Projets de règlements P-05-035 et P-04-047-02
Arrondissement Côte-des-Neiges-Notre-Dame-de-Grâce
CUSM/Hôpital des Shriners

Brief for presentation to the Office de Consultation Publique de
Montréal: The de Maisonneuve north side bikeway

By John Bishop

Submitted June 14th, 2005

SKETCH SHOWING PROPOSED

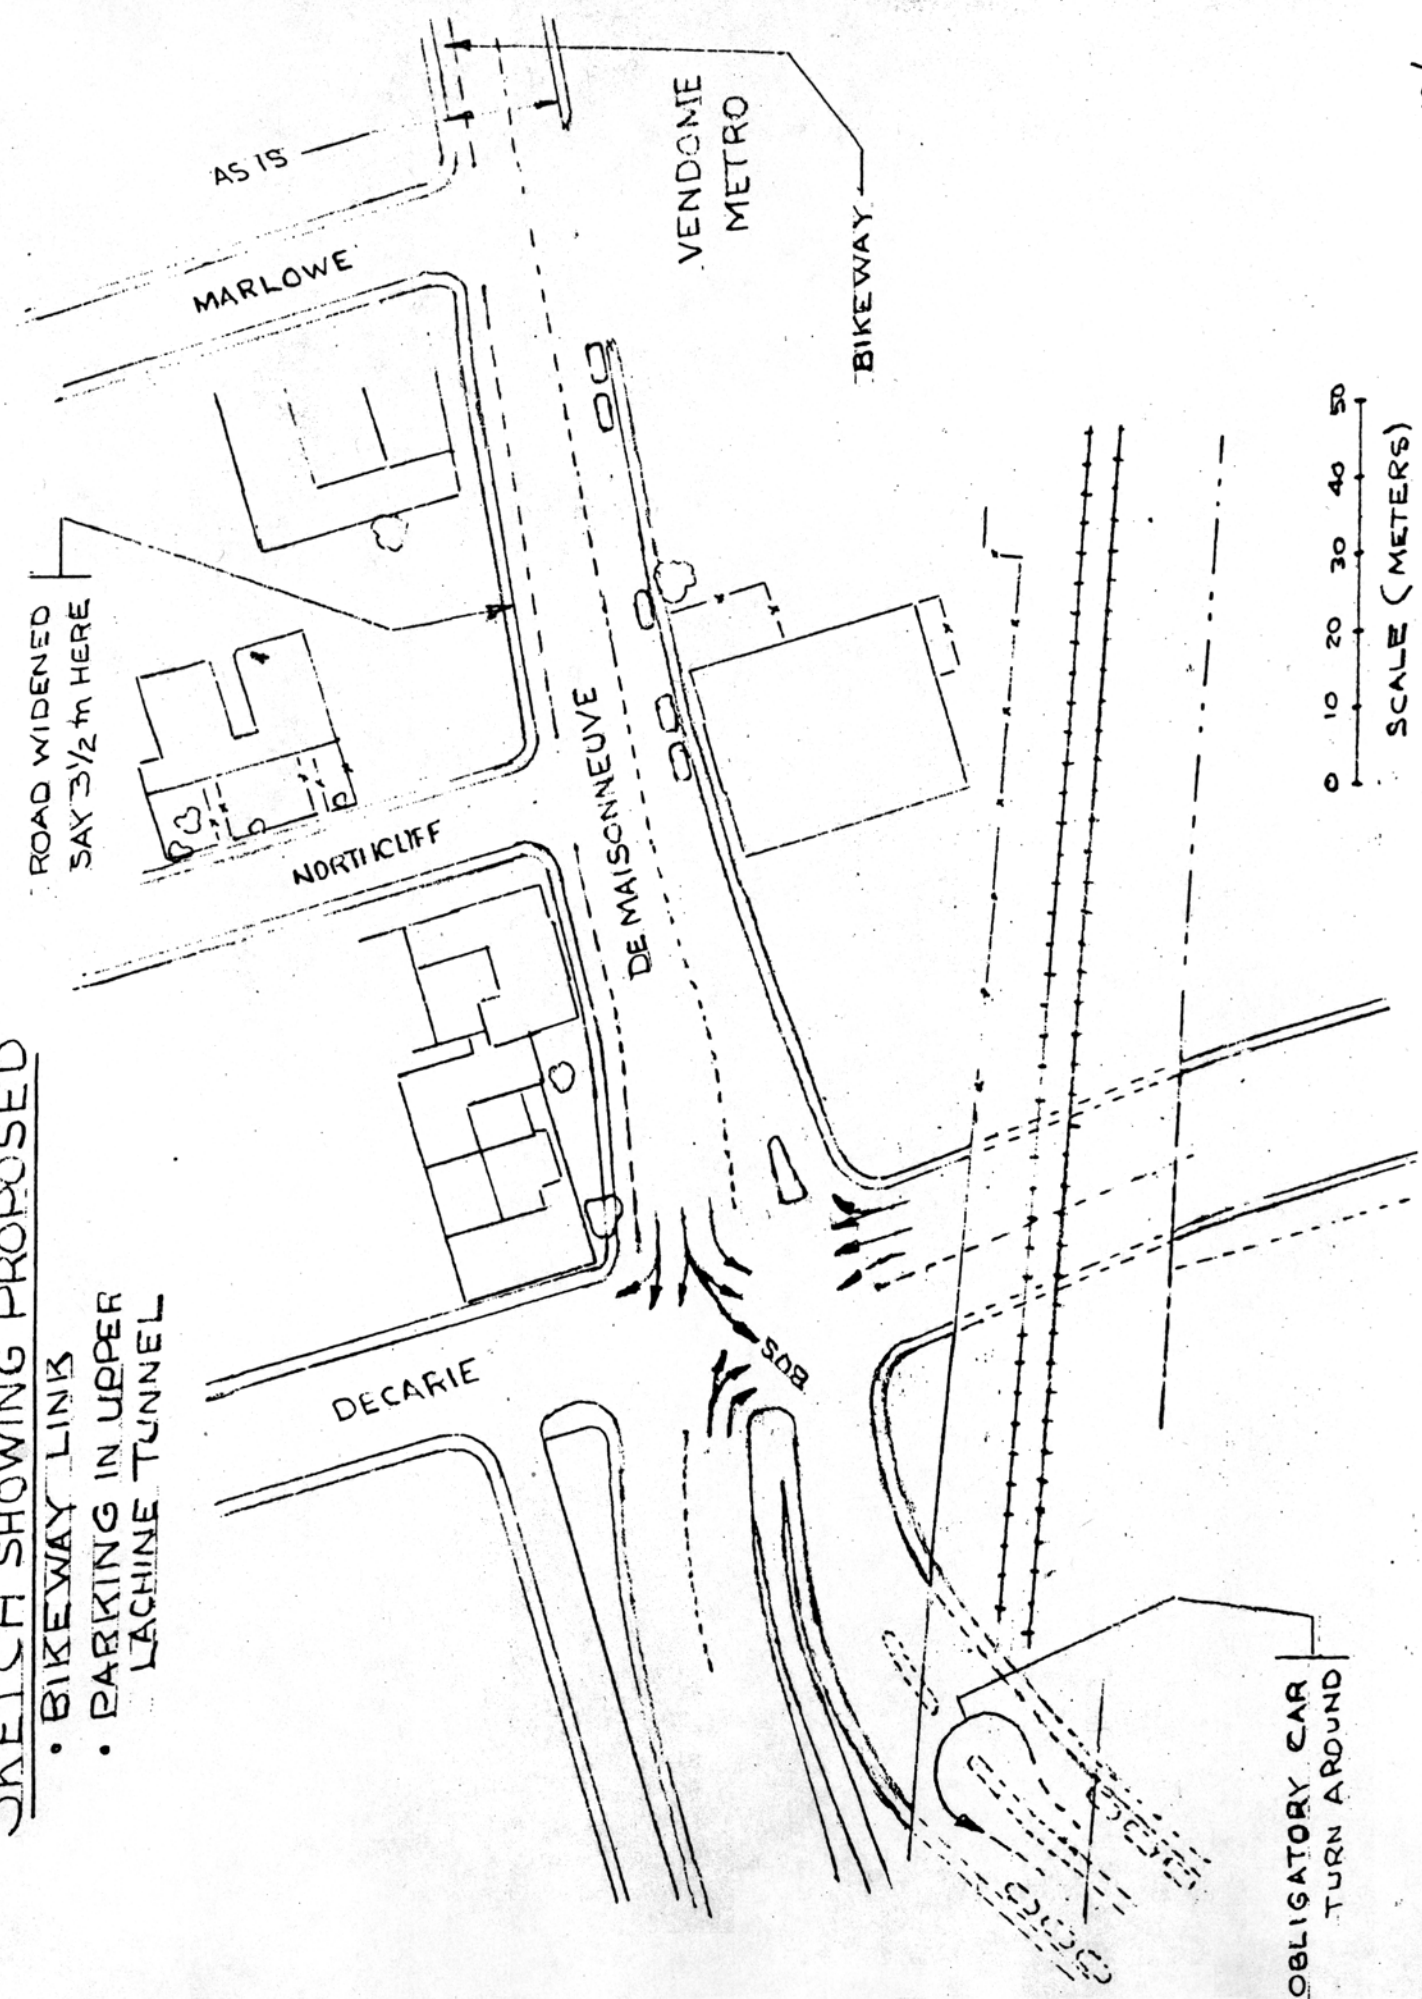
1. (a) Would be PERMANENTLY ROAD MARKED from Decarie to the beginning of the present car parking west of Vendome, and from the end of the present car parking west of Bulmer to Claremont.
- (b) Would POSSIBLY ONLY EXIST AT WEEKDAY RUSH HOURS in the remaining approximately 50% portion. Parking would be permitted in the existing 18 spaces in the non rush hours.*See sketch.

The proposed bike route through the new hospital grounds would be at least 65% longer and thus get little use. The direct route will best connect two existing long E/W bikeways.

Space for pay parking of over 45 cars should be provided along both sides of the tunnel roadway. The entrance and exit would only be from the Girouard end. See the main sketch regarding the east end turnaround.
